A/E Firm: WRA Architects		PM Firm: CBRE Vanir JV	Date: 12-10-2025
Org #: 159	School Name: L.L. Hotchkiss Elementary School	Bid Pack #/ CSP#: 207325	Addendum #: 1

**DALLAS INDEPENDENT SCHOOL DISTRICT
PROCUREMENT SERVICES
ADDENDUM NO. 1
CSP 207325 – L.L. Hotchkiss Elementary School - Renovation**

The Purpose of this Addendum No. 1 is to provide an alternate bid and updated the drawings and specifications:

REVISIONS:		
No.	Date	
ADDENDUM NO. 1	12/10/2025	
JOB NO.	2239	
DATE:	12/10/2025	
GRADING PLAN - BID ALTERNATE		
C3.02

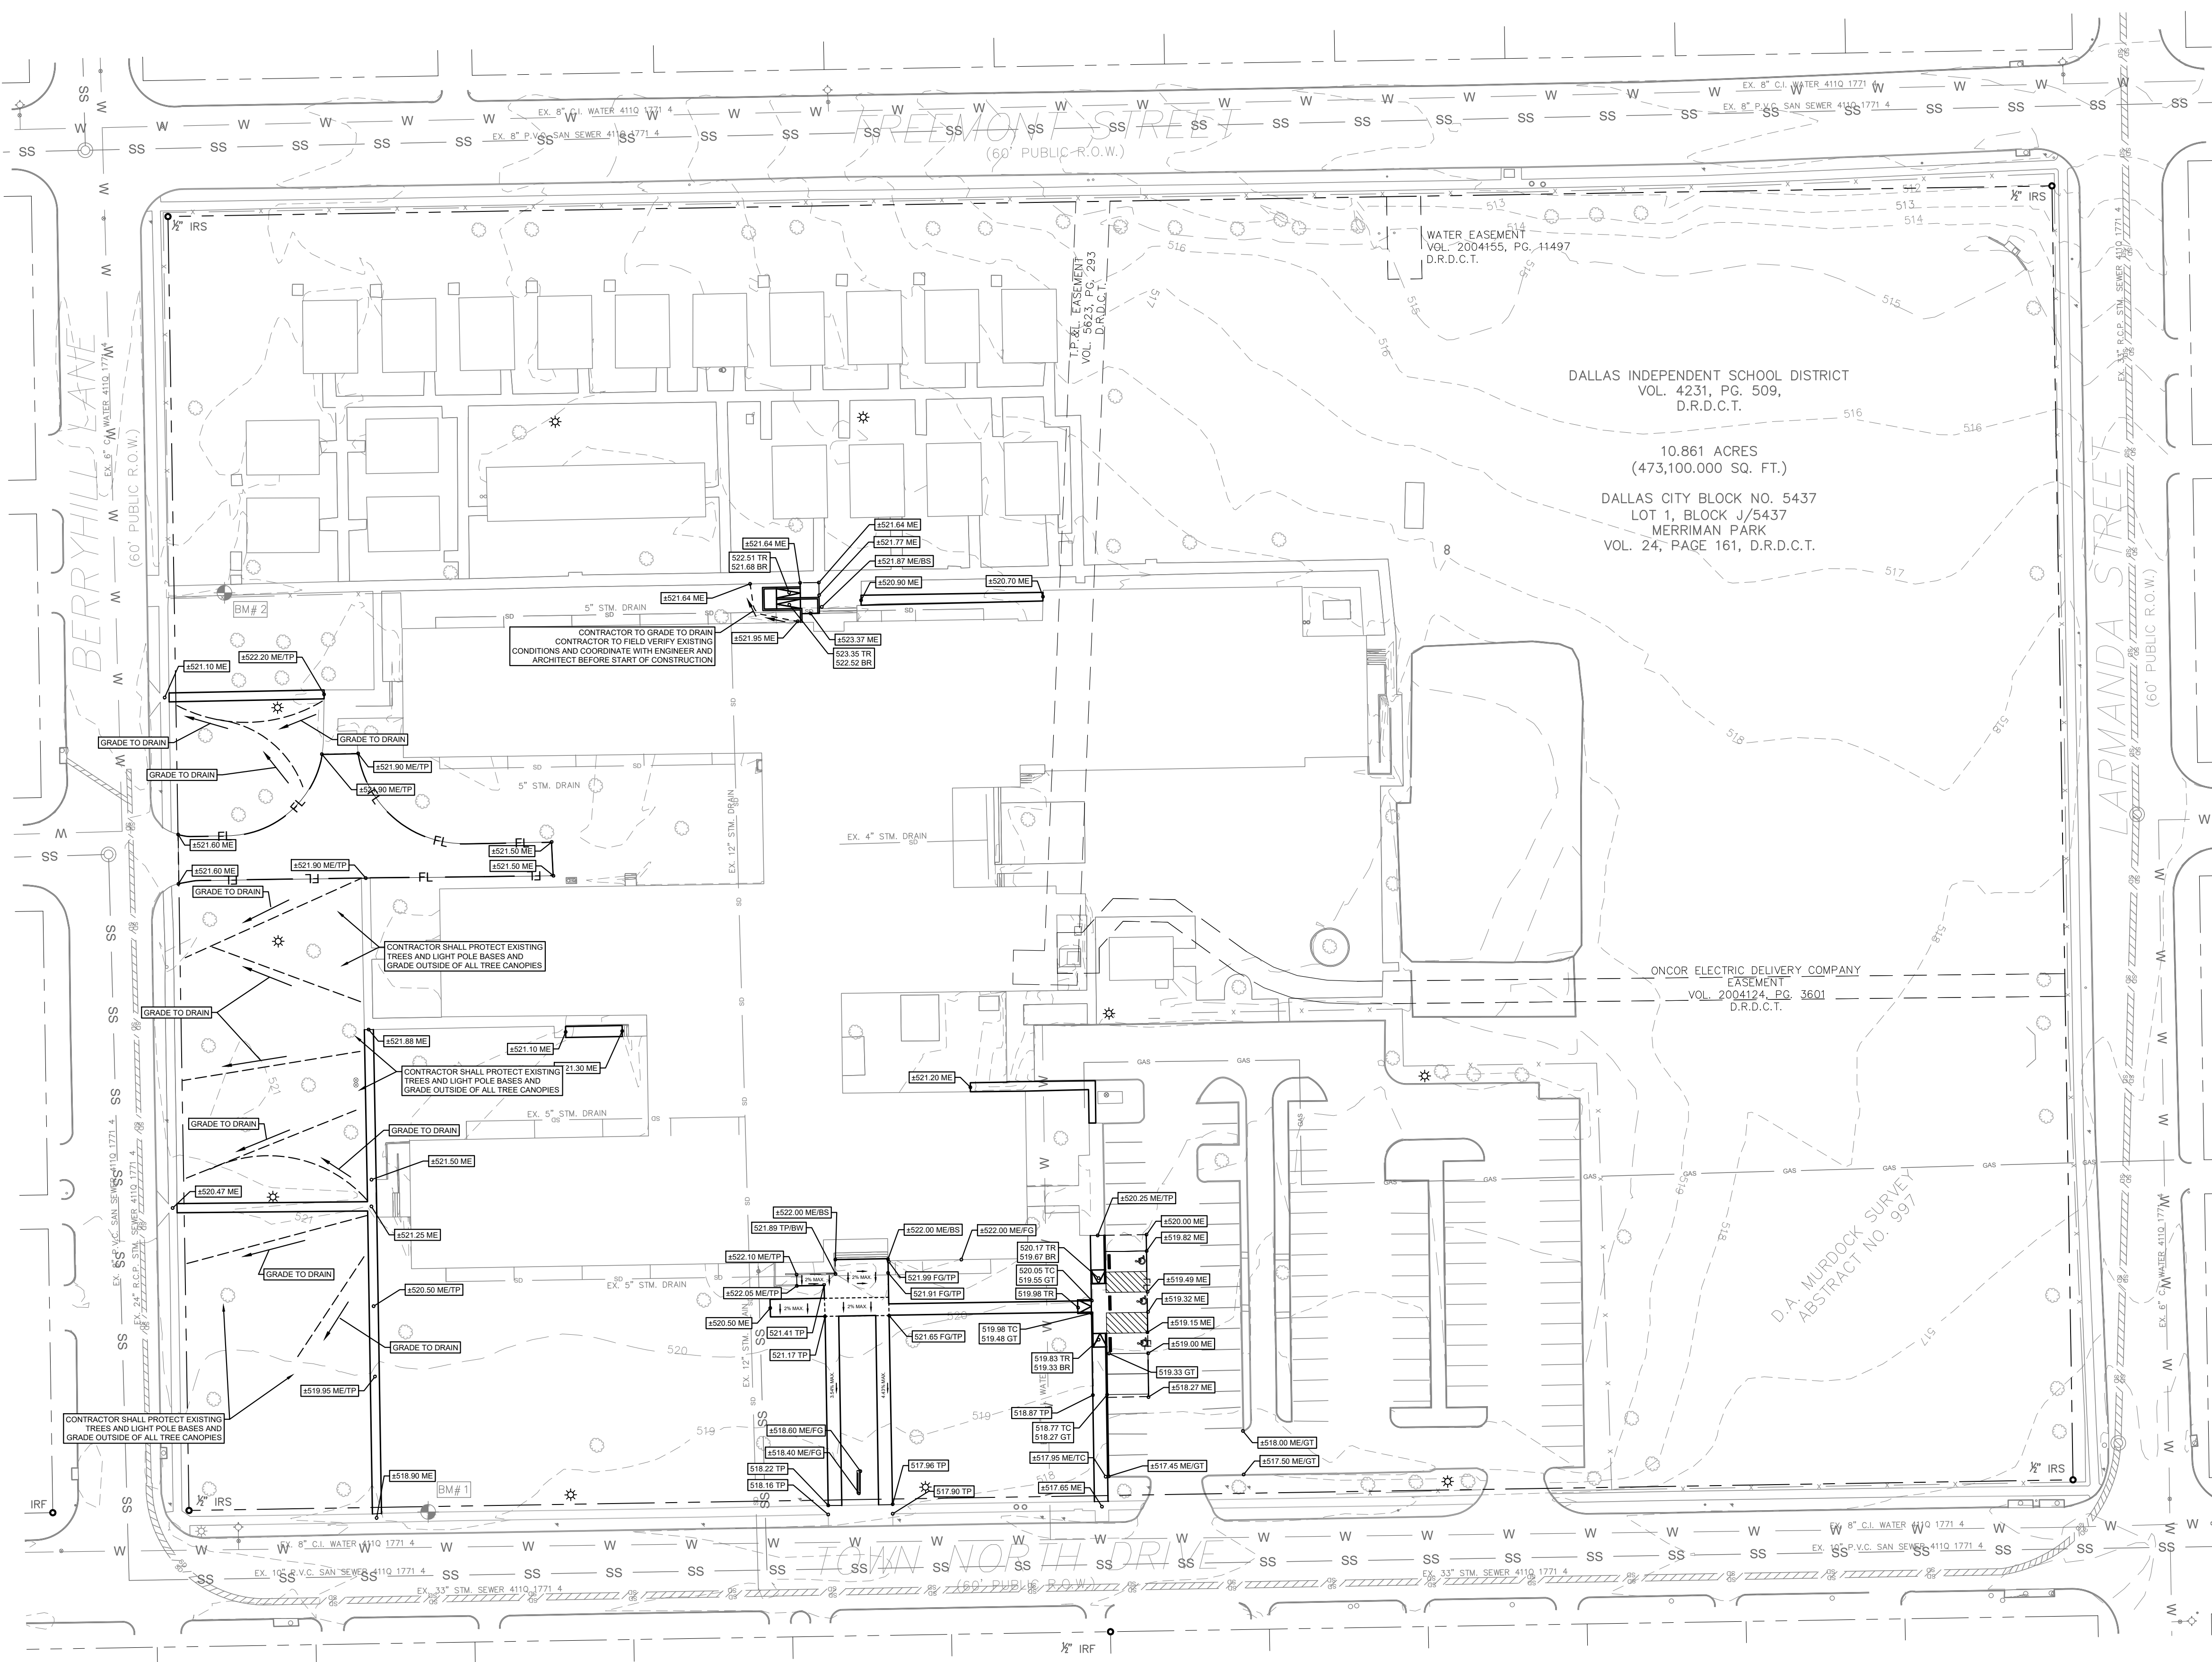
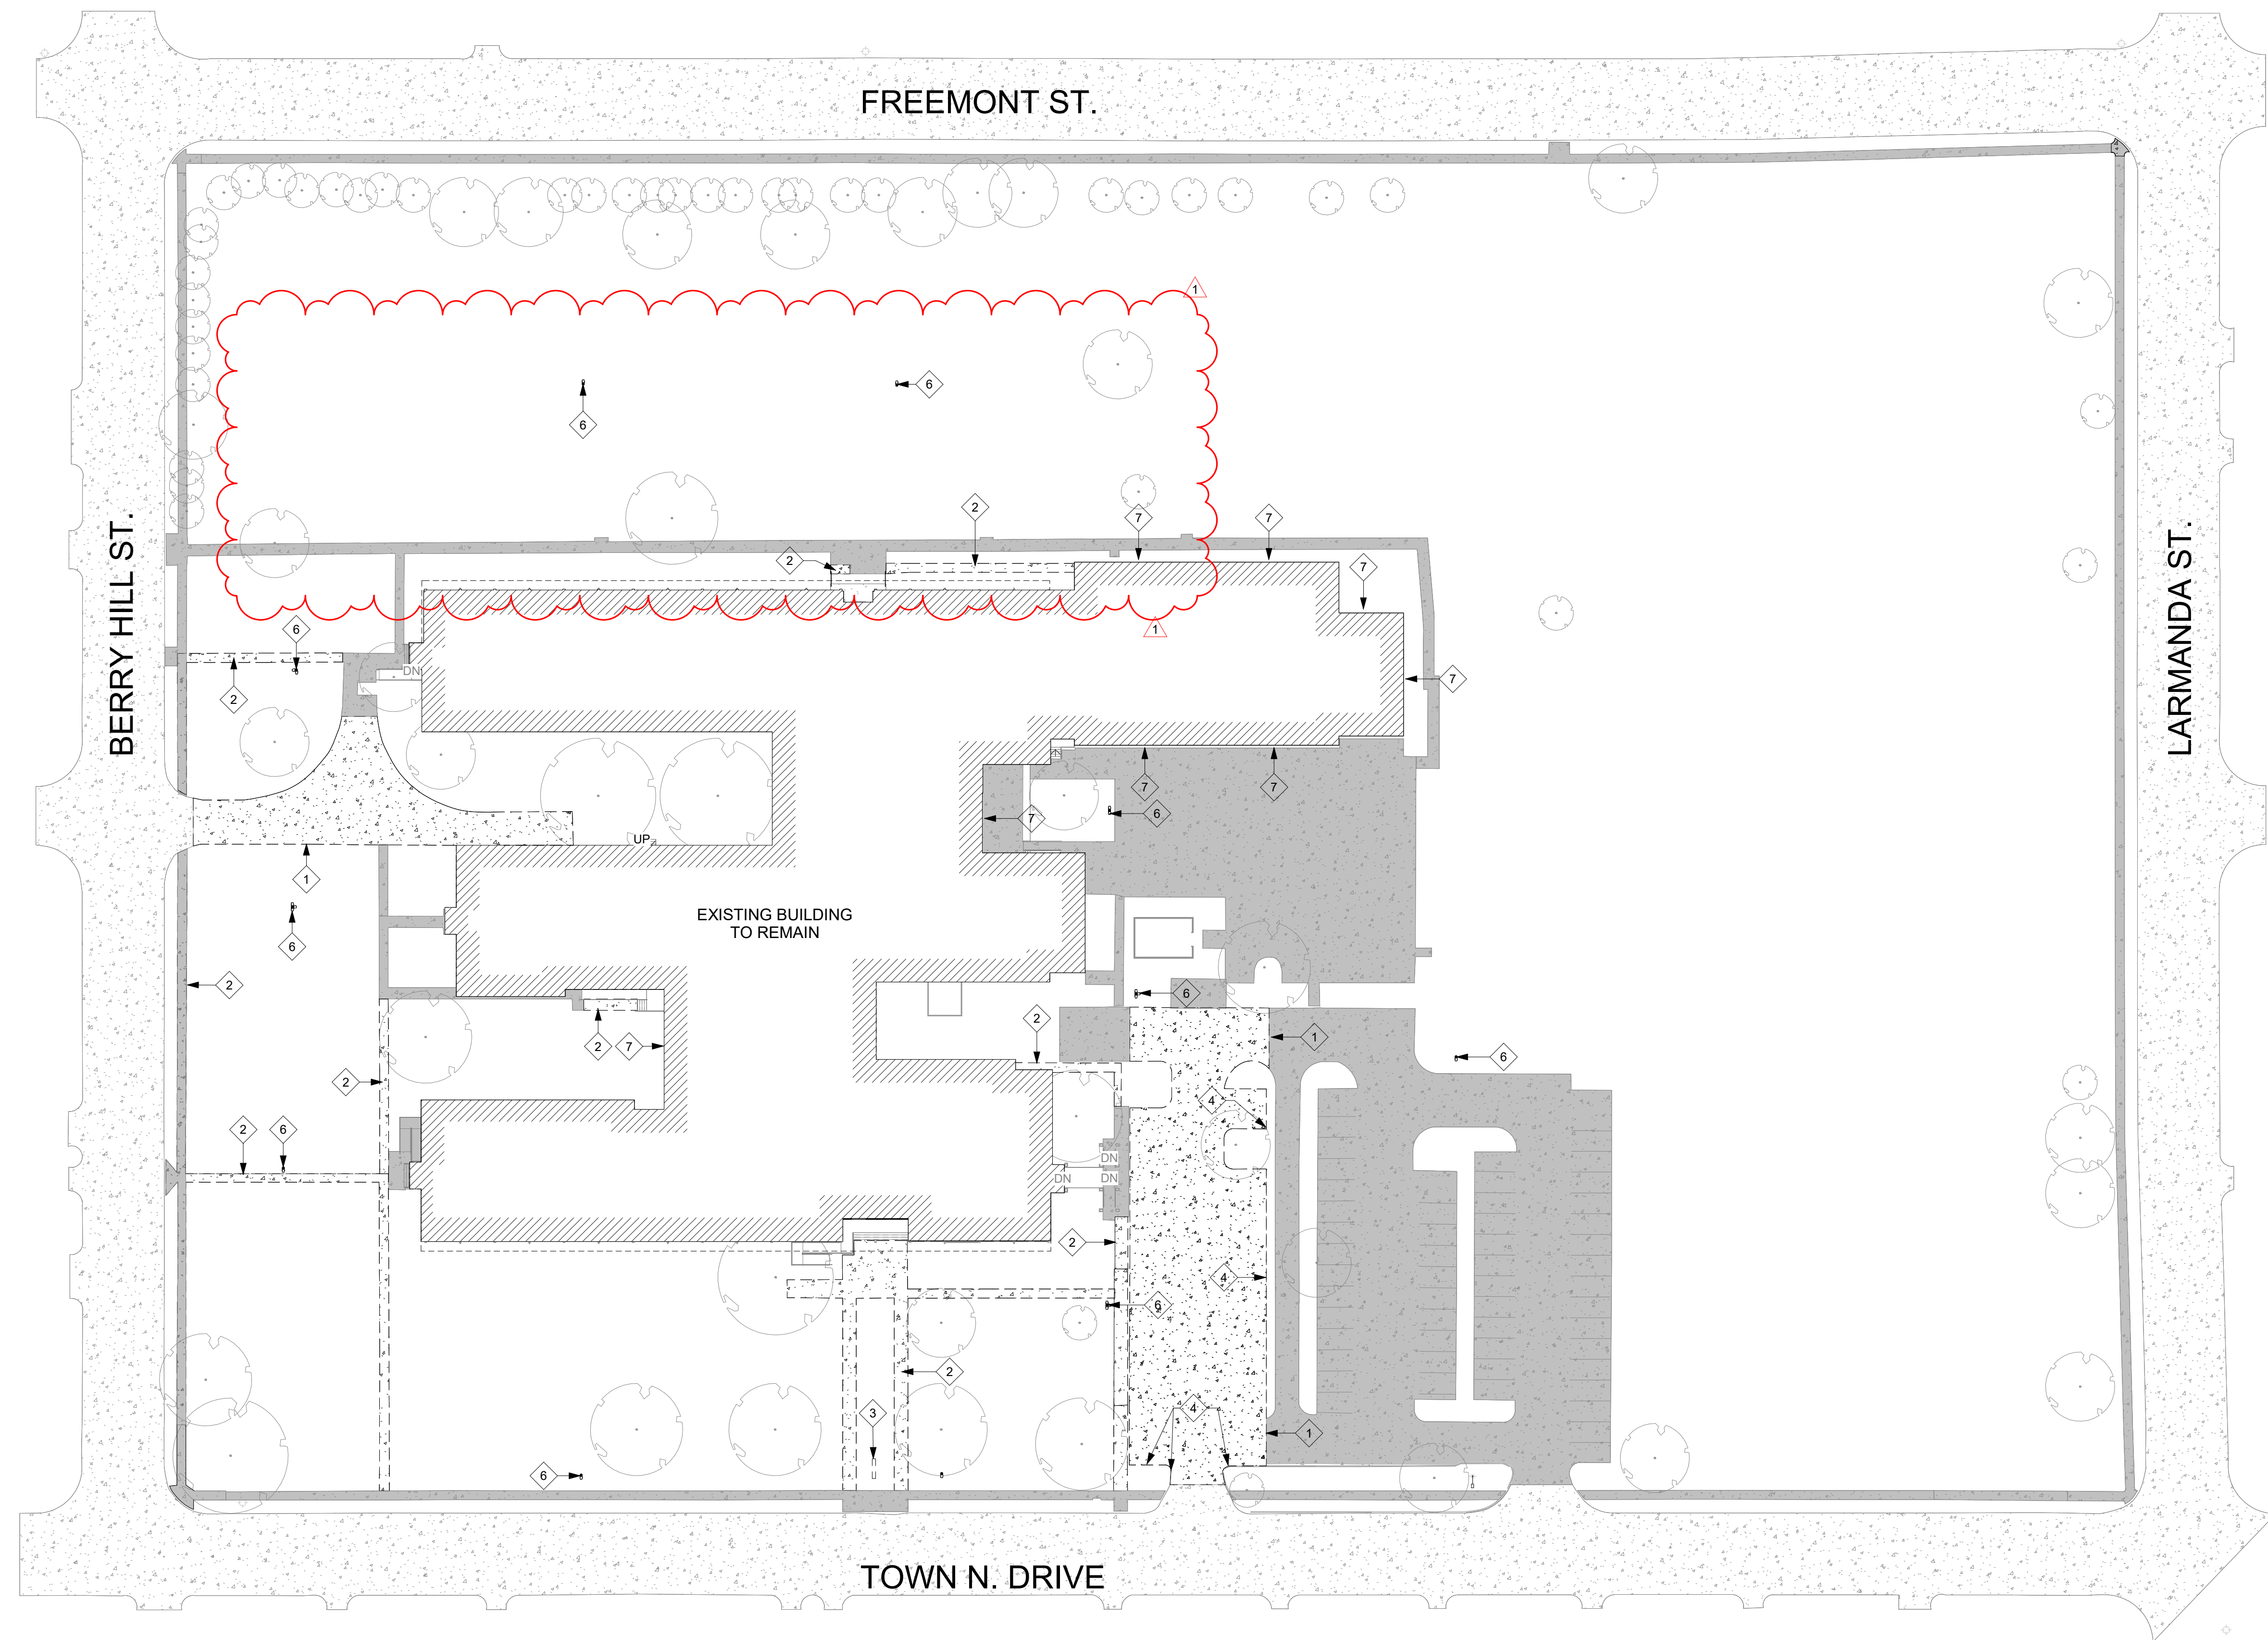
- A. REVISED** the south parking grading spots to the proposed sidewalk and ADA stalls only

1 Overall Site Plan
1" = 40'-0"

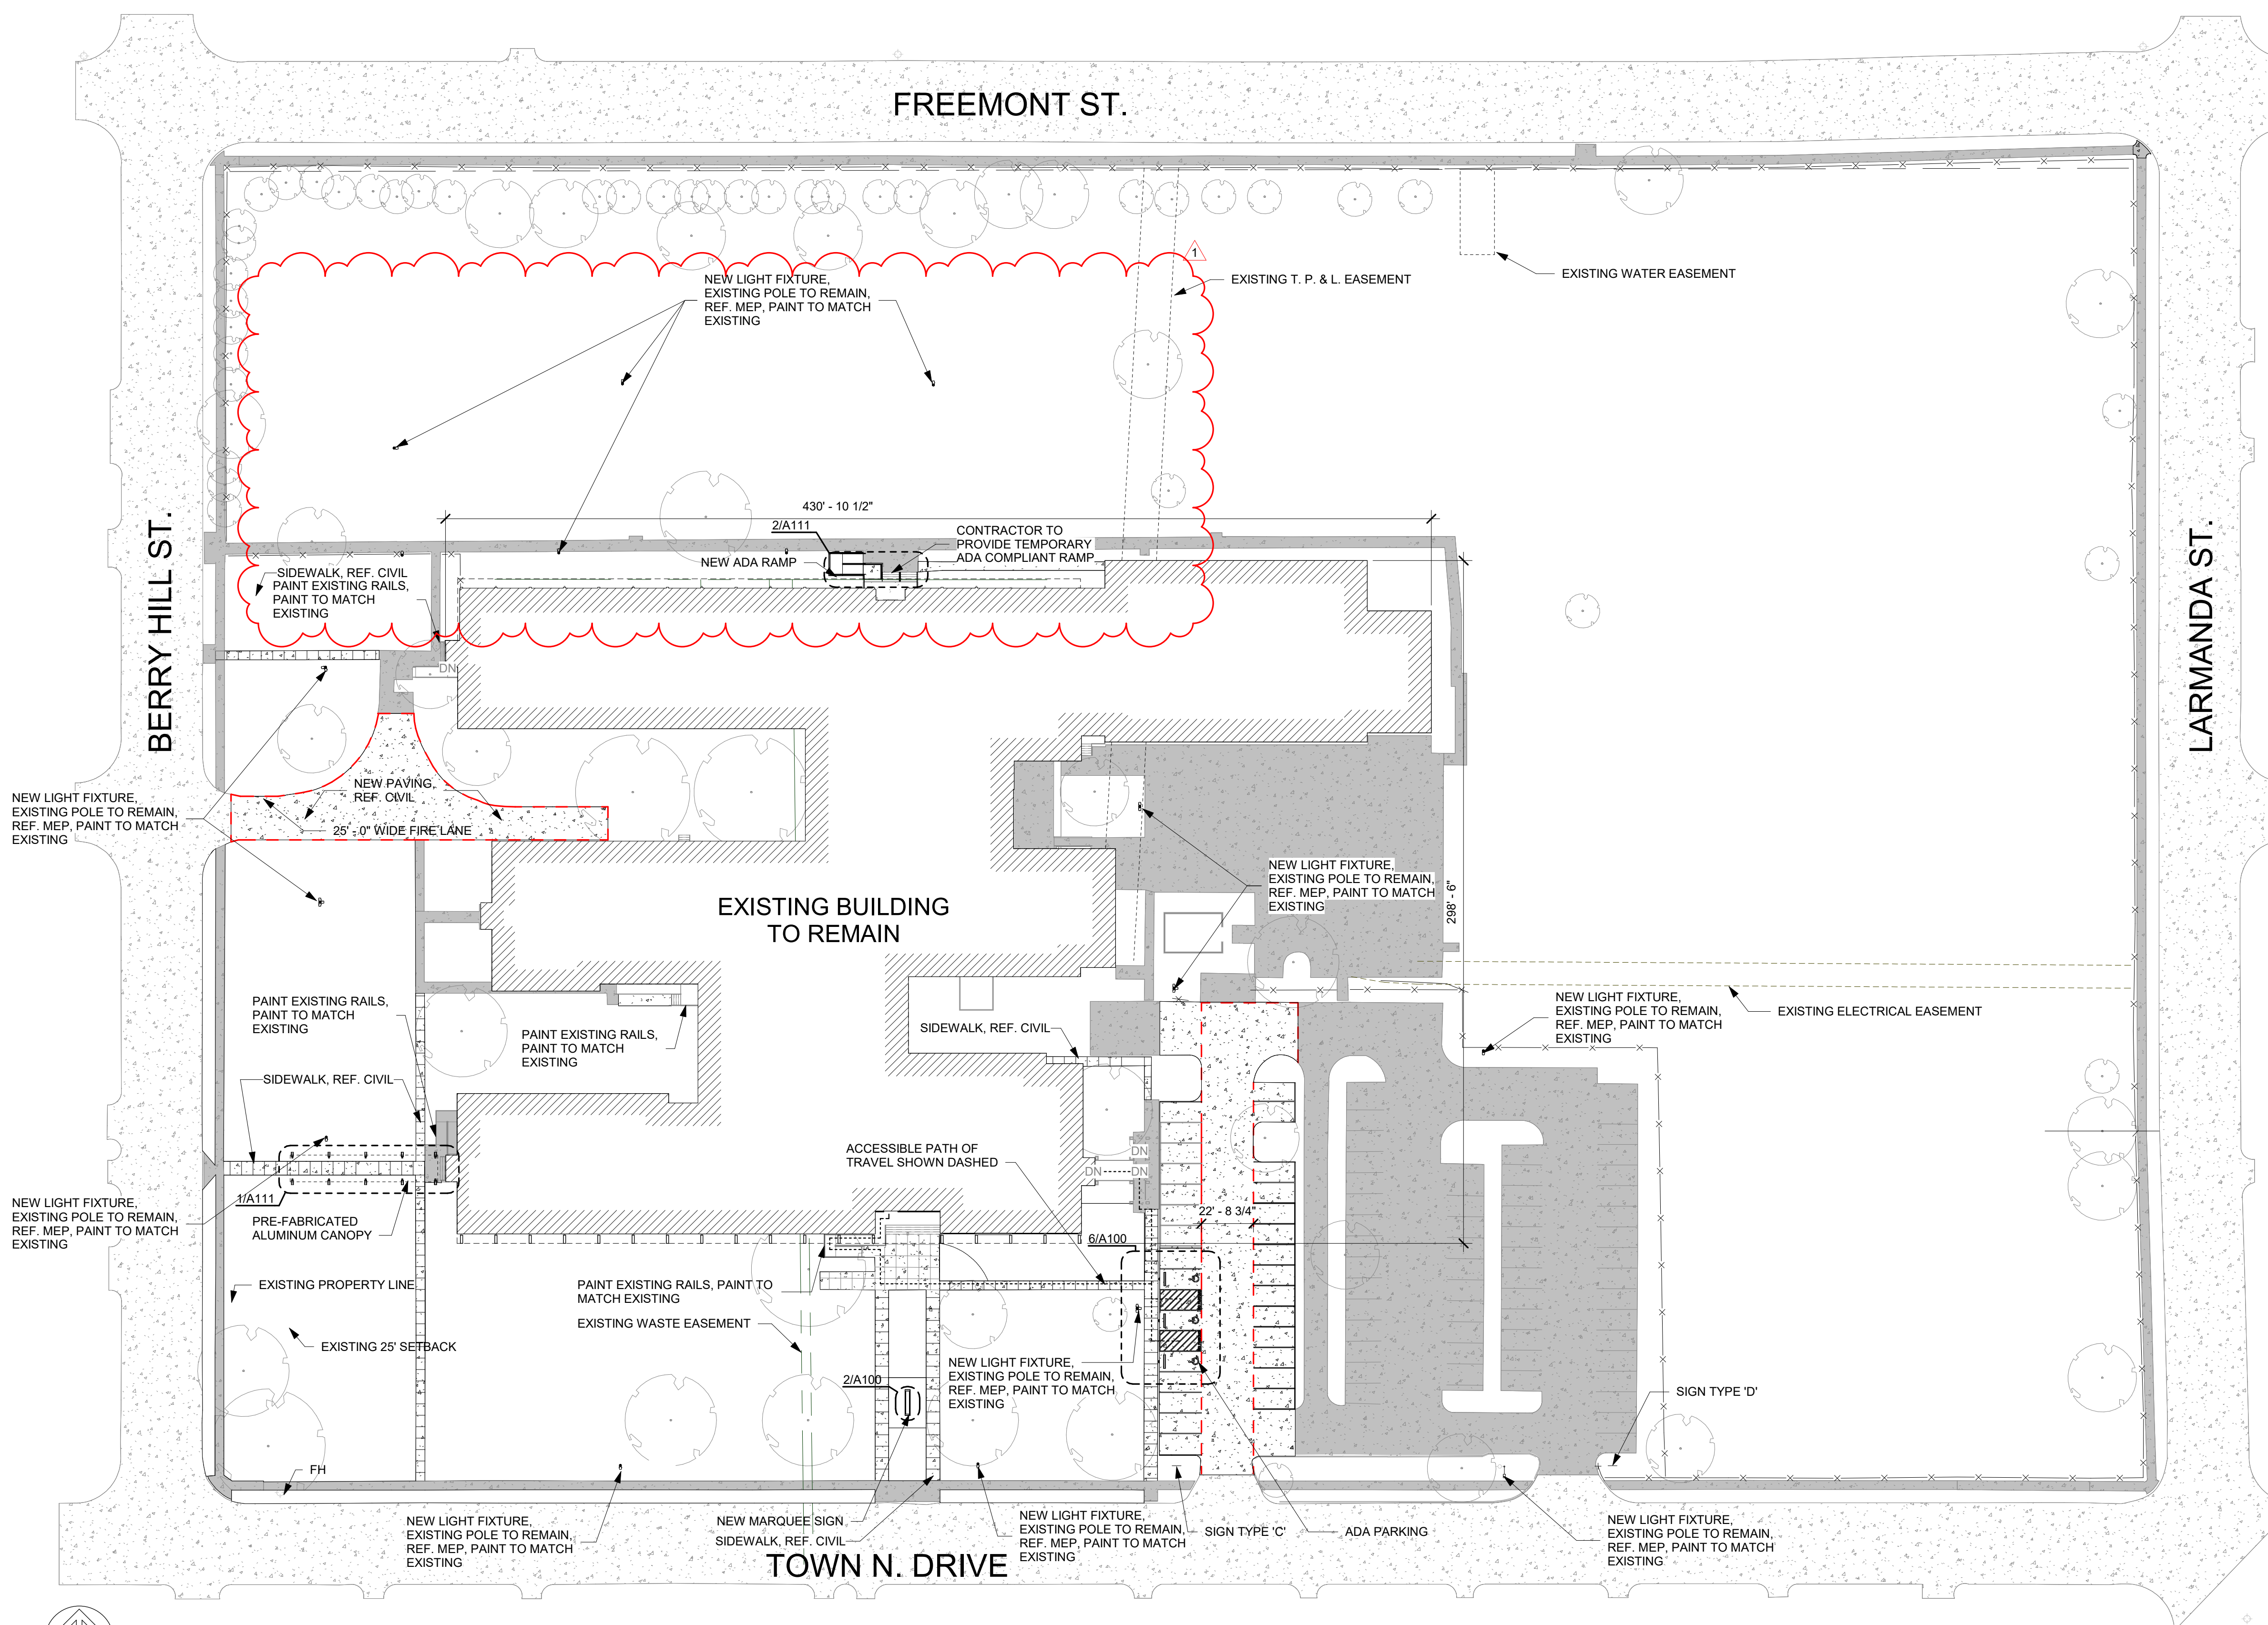
- A. CLARIFIED** no portables on existing site conditions
- B. REVISED** height of marquee masonry Detail 3, 4, 5 of A100
- C. REVISED** dimensions to detail 6/A100
